Re: Initial Submission Review – Montview Elementary School Addition – Redevelopment Plan
Application Number: **DA-2152-00**

Initial Submission Review

Sheet 2

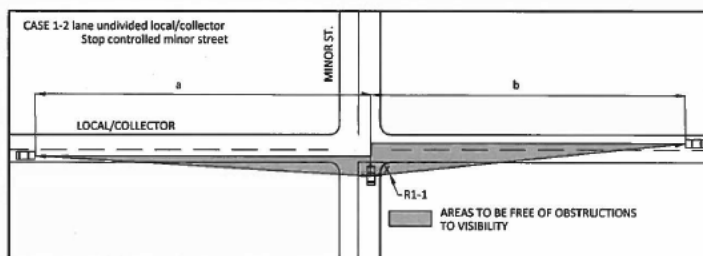
- Please use standard TE-13.1. The STD TE-13.1 has significantly longer lengths that extend into the roadway. Please update.
